09/496,374

Masami Kidono

Office Action Summary

DETAILED ACTION

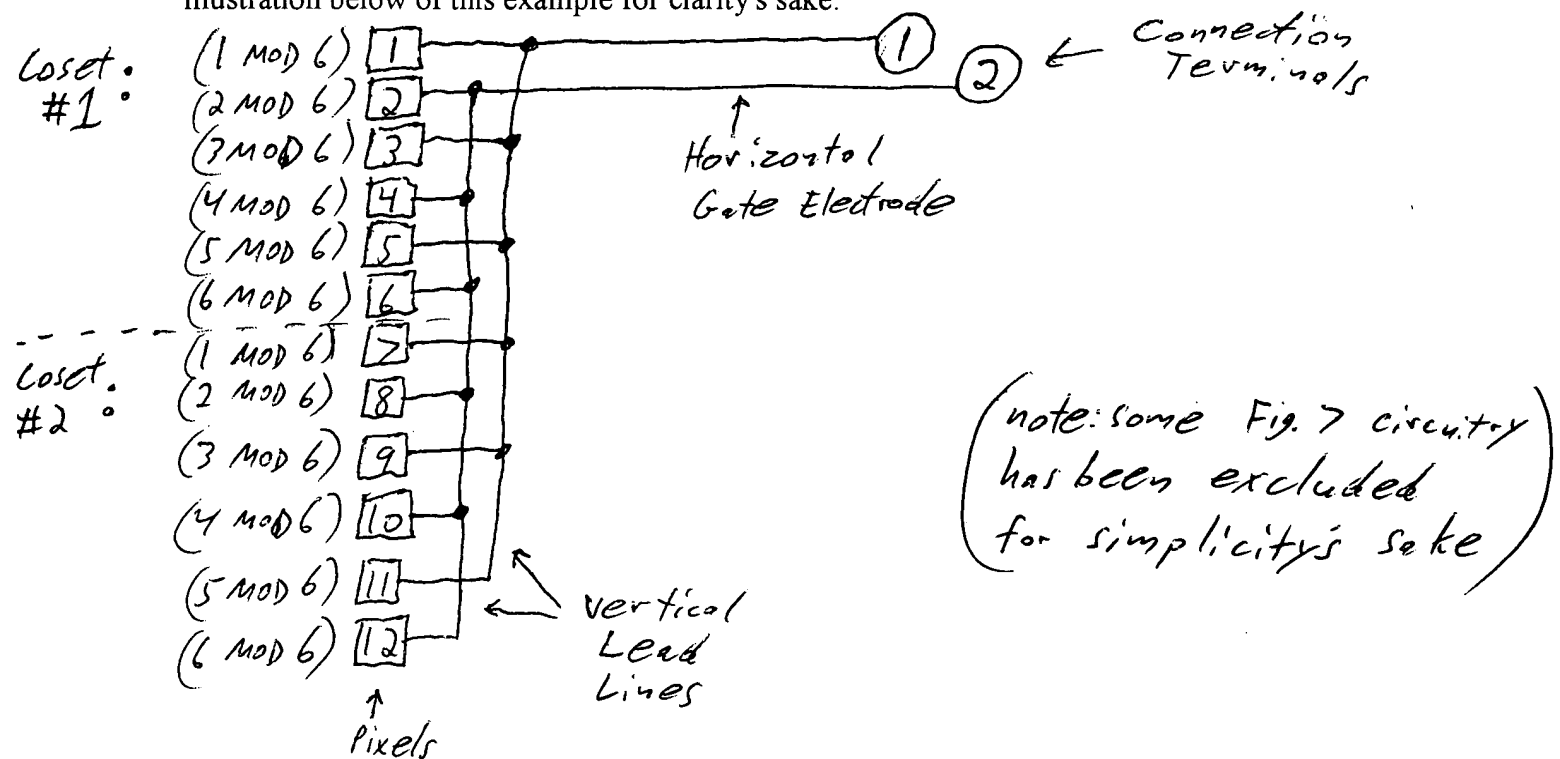
Additionally, the applicants contend that the current application's own admitted prior art does not teach the gate electrodes making up N of gate electrode groups in which the lines belonging to each coset of modulo N within successive pixel rows are connected to common lead lines. However, the examiner must again respectfully disagree. Although Figure 7 illustrates an imaging device with 16 connection terminals; the examiner, for reasons of brevity and conceptual simplicity, will instead rely upon an example duplicating Figure 7's pixel-to-terminal wiring design, but only comprising two connection terminals. It is noted however, the following example circuitry arrangement can be easily extrapolated to include 16 (or more) connection terminals -- increasing the modulo and complexity accordingly.

In this example, there are twelve pixels [Fig 7; 1]. Two connection terminals [Fig. 7; 6]. The gate electrodes [Fig. 7; 4A - horizontal lines] making up six (where $N = 6$) of gate electrode groups -- effectively dividing the twelve pixels total into two separate cosets of six pixels each. Connection terminal #1 is connected to odd-numbered pixels 1, 3, 5, 7, 9, & 11. Connection

terminal #2 is connected to even-numbered pixels 2, 4, 6, 8, 10, & 12. That is, in other words, connection terminal #1 is connected to pixels 1 MOD 6, 3 MOD 6, & 5 MOD 6; and connection terminal #2 is connected to pixels 2 MOD 6, 4 MOD 6, & 6 MOD 6 -- this remains true for the first coset of 6 pixels as well as the second coset of 6 pixels. The examiner has included a rough illustration below of this example for clarity's sake.

Following from the above example, it is clearly evidenced that current application's own admitted prior art does teach the gate electrodes making up N of gate electrode groups in which the lines belonging to each coset of modulo N within successive pixel rows are connected to common lead lines. The above example, with only 2 *connection terminals* and 12 *pixels*, is *modulo 6*. However, Figure 7, with 16 *connection terminals* and 544 *pixels*, would be *modulo 272*. By such reasoning, rejection of the claims is deemed necessary, proper, and thereby maintained at this time.
